Office Action Summary	Application No. 10/536,599	Applicant(s) WATANABE ET AL.	
	Examiner EUGENIA WANG	Art Unit 1795

DETAILED ACTION

3. Claim 42-45, 47-52, 56, and 62 are rejected under 35 U.S.C. 103(a) as being unpatentable over WO 00/14819 (Chizawa et al.) in view of US 2002/0028364 (Kaufmann). It is noted that US 6613467 is being relied upon as an English translation of the corresponding WO document.

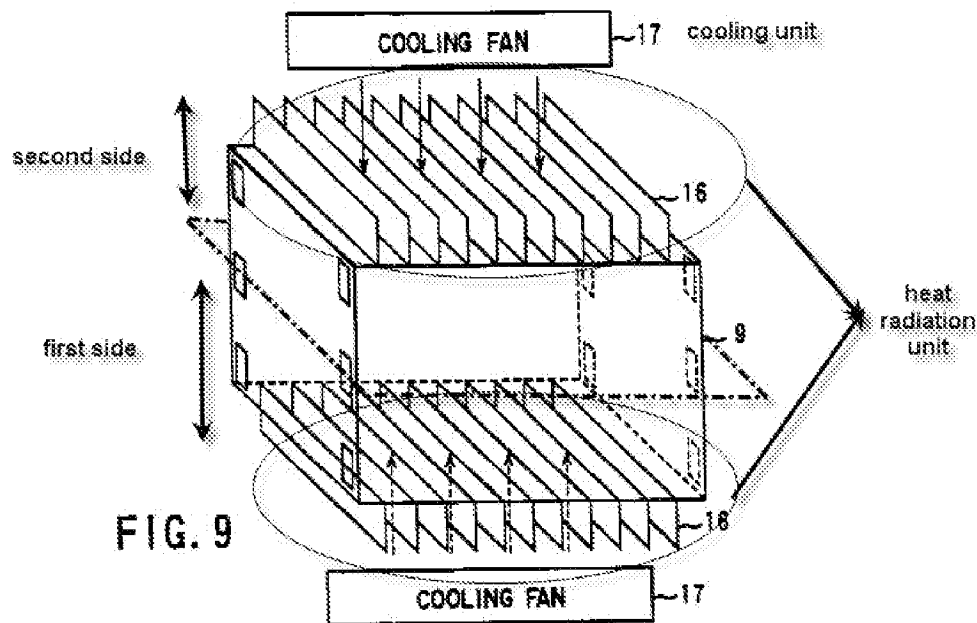
As to claim 42, Chizawa et al. teach of a general fuel cell system, which has a plurality of fuel cells [4] which react electrochemically to create power (power generation units) (col. 1, lines 30-43; fig. 1). It is stated that oxygen is fed to the system (and thus some conduit containing oxygen gas must exist) (col. 1, lines 48-51). It is specifically noted that Chizawa et al. embodies such a typical fuel cell with modifications, as there is a statement as to only differences to the general fuel cell of fig. 1 will be described in their embodiments (col. 2, lines 26-28). In one particular embodiment, cooling unit, specifically radiation fins [16], for radiating heat to the outer atmosphere (heat radiation unit) is embodied (col. 5, lines 5-10; col. 12, lines 55-59; fig. 9). The fins [16] below the stack [9] are interpreted to be connected to a first side (lower half of the fuel cell system), while the fins [16] above the stack [9] are on a second side (upper half of the fuel cell system). It is noted that the system has gas-feeding means (gas flow unit) for

the reactants (thus encompassing both oxidant and fuel), wherein the gas-feeding means feeds each reactant separately into the separator (col. 5, lines 5-10). It is noted that the oxidant gas (air embodied) is necessarily fed into a first intake port (on the power generation unit) such that the air can be delivered to the cathode (col. 1, lines 47-51; fig. 10). (Although such an intake port is not labeled in fig. 9, it can be seen as the unlabeled rectangles at the end of the stack in fig. 9, wherein these ports are in the same position as the other labeled embodiments; compare to figs. 2-8, wherein for example such ports are labeled in fig. 7, wherein fig. 8 shows the same type of delivery as that of fig. 10. Accordingly, such a first intake port would necessarily exist in the embodiment of fig. 9, or else the reactants would not be able to be delivered to the cells within the stack.) It is noted that such an intake port is located on the second side of the fuel cell (upper half). Fig. 9 shows that there are cooling fans [17] (cooling units) that direct (suck) air to cool the radiation fins [16] (heat radiation unit) (fig. 9; col. 12, lines 45-55). It is noted that the upper cooling fan [17] (cooling unit) is located on the second side (upper half of the fuel cell system) and directs the air of the portion of the cooling unit that lies that second side. It can be interpreted that the openings defined by the upper radiation fins [16] constitute a composite second intake port (on the power generation unit, as it is attached to the fuel cell stack [9]), wherein, as such a place is near that of the first intake port (rectangular unlabeled sections, in fig. 9), that the composite second intake port is adjacent to the first intake port, barring specification as to what constitutes adjacent. Office personnel are to give claims their broadest reasonable interpretation in light of the supporting disclosure. *In re Morris*, 127 F.3d

1048, 1054-55, 44 USPQ2d 1023, 1027-28 (Fed. Cir. 1997). Also, limitations appearing in the specification but not recited in the claim are not read into the claim. See *In re Zletz*, 893F.2d 319, 321-22, 13 USPQ2d, 1320, 1322 (Fed. Cir. 1989). Again, since such a second intake port is on the upper half, it is on a second side of the power generation unit. (It noted that the fans are necessarily driven independently from the gas flow unit, as the reactants are line to the fuel cells (as state within col. 5, lines 5-10), and fig. 9 shows that the fans are directed to the stack externally (via the arrows).) See annotated figure (fig. 9 of Chizawa et al.) below for interpretation taken:

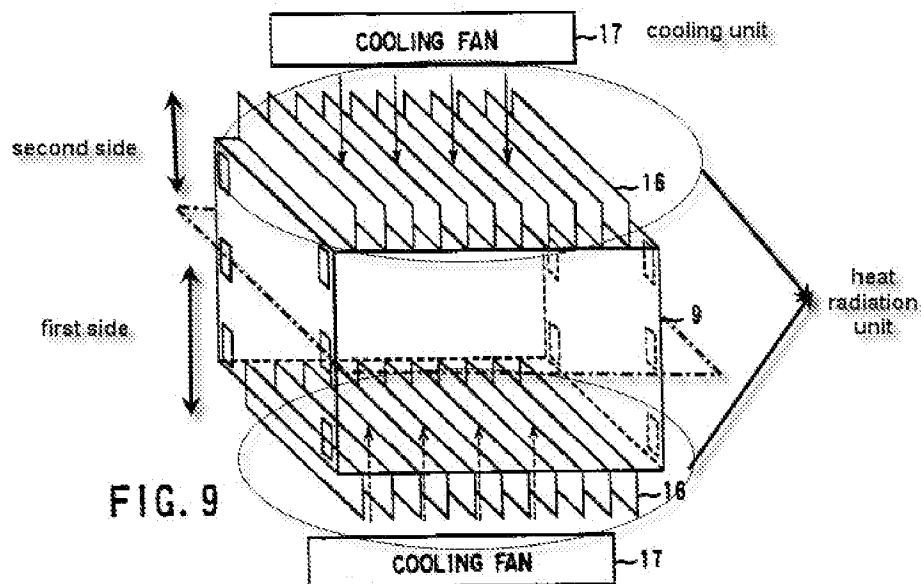
As to claim 81, Chizawa et al. teach of a general fuel cell system, which has a plurality of fuel cells [4] which react electrochemically to create power (power generation units) (col. 1, lines 30-43; fig. 1). It is stated that oxygen is fed to the system (and thus some conduit containing oxygen gas must exist) (col. 1, lines 48-51). It is specifically noted that Chizawa et al. embodies such a typical fuel cell with modifications, as there is a statement as to only differences to the general fuel cell of fig. 1 will be described in their embodiments (col. 2, lines 26-28). In one particular embodiment, cooling unit, specifically radiation fins [16], for radiating heat to the outer atmosphere (heat radiation unit) is embodied (col. 5, lines 5-10; col. 12, lines 55-59; fig. 9). The fins [16] below the stack [9] are interpreted to be connected to a first side (lower half of the fuel cell system), while the fins [16] above the stack [9] are on a second side (upper half of the

fuel cell system). It is noted that the system has gas-feeding means (gas flow means) for the reactants (thus encompassing both oxidant and fuel), wherein the gas-feeding means feeds each reactant separately into the separator (col. 5, lines 5-10). It is noted that the oxidant gas (air embodied) is necessarily fed into a first intake port (on the power generation unit) such that the air can be delivered to the cathode (col. 1, lines 47-51; fig. 10). (Although such an intake port is not labeled in fig. 9, it can be seen as the unlabeled rectangles at the end of the stack in fig. 9, wherein these ports are in the same position as the other labeled embodiments; compare to figs. 2-8, wherein for example such ports are labeled in fig. 7, wherein fig. 8 shows the same type of delivery as that of fig. 10. Accordingly, such a first intake port would necessarily exist in the embodiment of fig. 9, or else the reactants would not be able to be delivered to the cells within the stack.) It is noted that such an intake port is located on the second side of the fuel cell (upper half). Fig. 9 shows that there are cooling fans [17] (cooling units) that direct (suck) air to cool the radiation fins [16] (heat radiation unit) (fig. 9; col. 12, lines 45-55). It is noted that the upper cooling fan [17] (cooling unit) is located on the second side (upper half of the fuel cell system) and directs the air of the portion of the cooling unit that lies that second side. It can be interpreted that the openings defined by the upper radiation fins [16] constitute a composite second intake port (on the power generation unit, as it is attached to the fuel cell stack [9]), wherein, as such a place is near that of the first intake port (rectangular unlabeled sections, in fig. 9), that the composite second intake port is adjacent to the first intake port, barring specification as to what constitutes adjacent. Office personnel are to give claims their broadest

reasonable interpretation in light of the supporting disclosure. *In re Morris*, 127 F.3d 1048, 1054-55, 44 USPQ2d 1023, 1027-28 (Fed. Cir. 1997). Also, limitations appearing in the specification but not recited in the claim are not read into the claim. See *In re Zletz*, 893F.2d 319, 321-22, 13 USPQ2d, 1320, 1322 (Fed. Cir. 1989). Again, since such a second intake port is on the upper half, it is on a second side of the power generation unit. (It noted that the fans are necessarily driven independently from the gas flow unit, as the reactants are line to the fuel cells (as state within col. 5, lines 5-10), and fig. 9 shows that the fans are directed to the stack externally (via the arrows).) See annotated figure (fig. 9 of Chizawa et al.) below for interpretation taken:
